GTR9-8-03

GTR9 – Draft Working Document of IG GTR9 PH2

Version 1, 04 Sept. 2013

Figure 12: Lower legform impactor (see paragraph 6.3.1.1.)

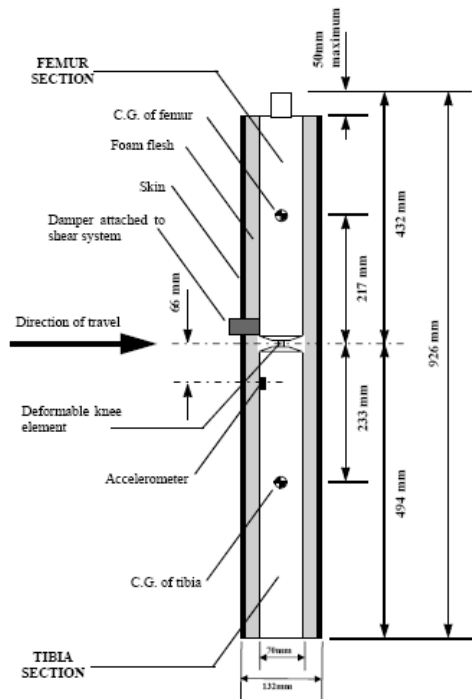
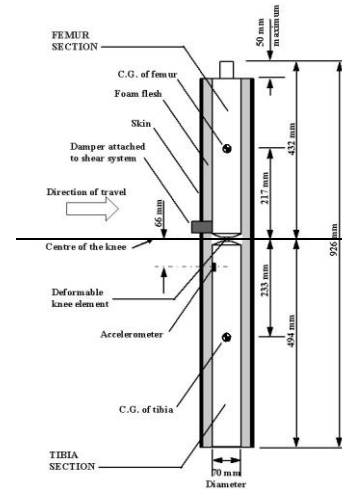
Delete Figures 12, to read:

Delete Figures 12 : delete figure for EEVC lower legform impactor.

Figure 12 Flexible lower legform impactor; Dimensions and C.G. locations of femur, knee joint and tibia (Side view)

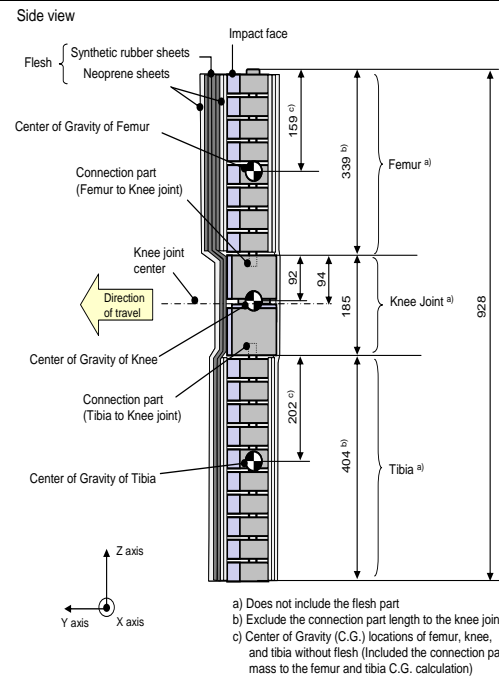
Insert new Figures 12 to 16, to read:

Figure 17 21 Flexible lower legform impactor Lower legform to bumper tests for complete vehicle in normal ride attitude (left) and for cut-body mounted on supports (right) (see paragraph 7.1.1.3.) "

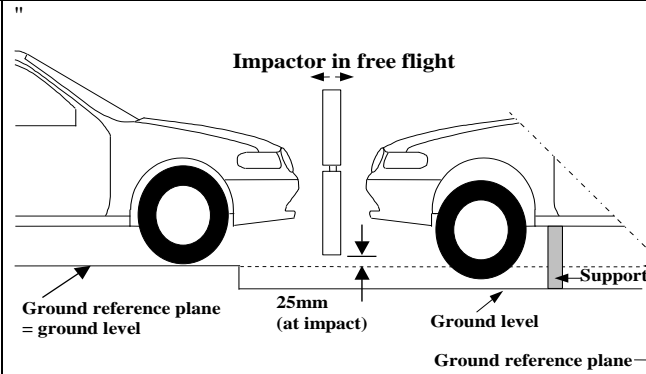
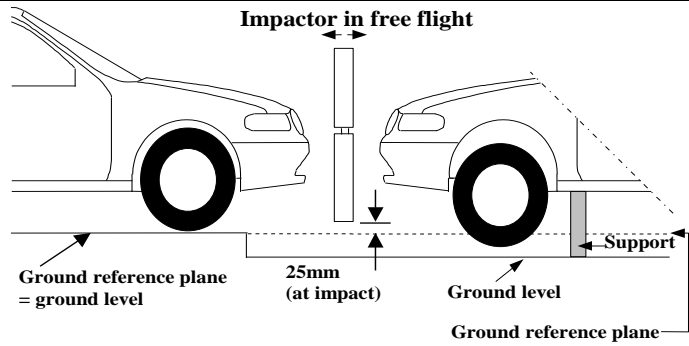
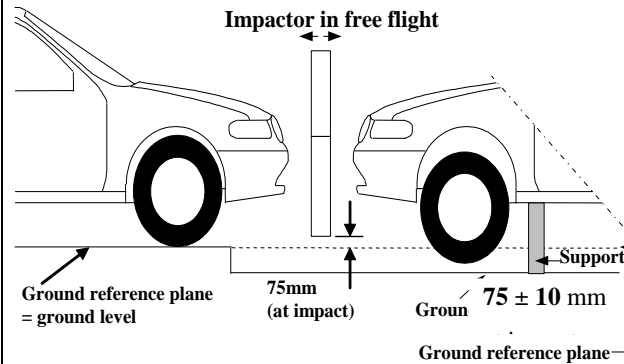
Figures 17(former), renumber as Figure 21 and amend to read:

Figure 17 (former): renumbering and replaced by flexible lower legform impactor requirements.

Figure 22 Flexible lower legform impactor requirement corridor of femur and tibia in static certification test (see paragraph 8.1.1.2.)

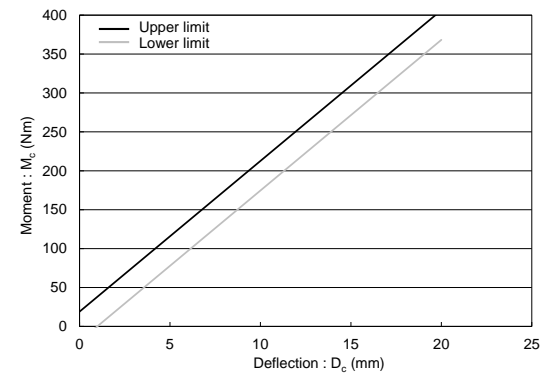
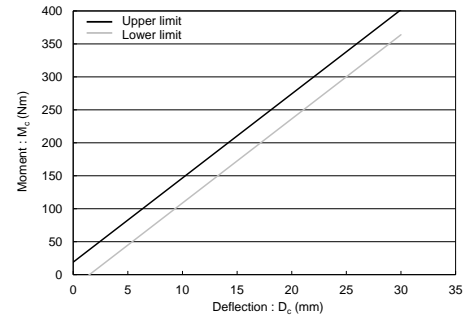
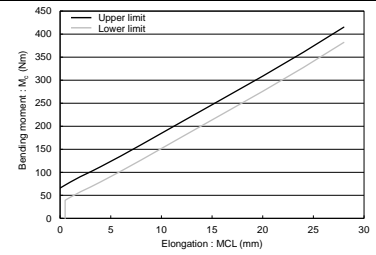
Insert new Figures 22 to 28., to read:

Figure 18: Force versus angle requirement in static lower legform impactor bending certification test (see paragraph 8.1.1.2.)

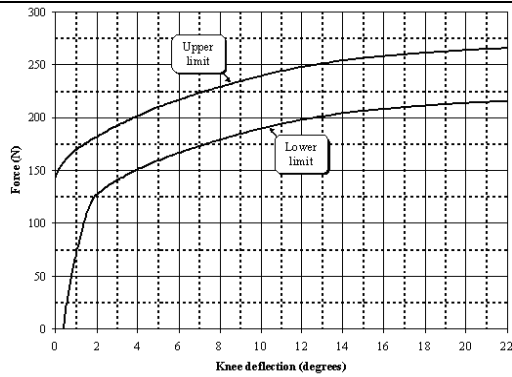
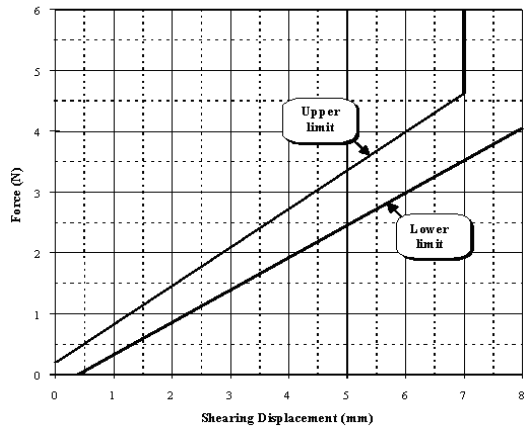
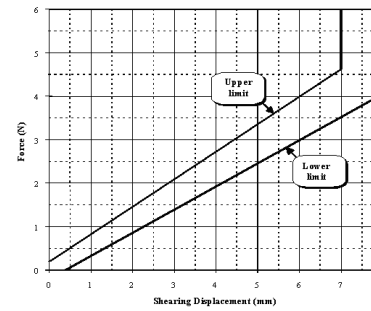
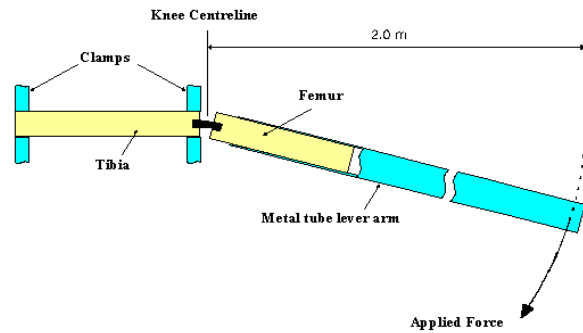
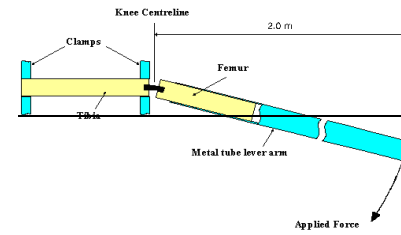
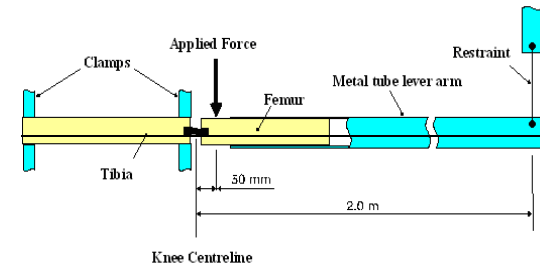
Delete Figures 18 to Figure 21 : delete figure for EEVC lower legform impactor.
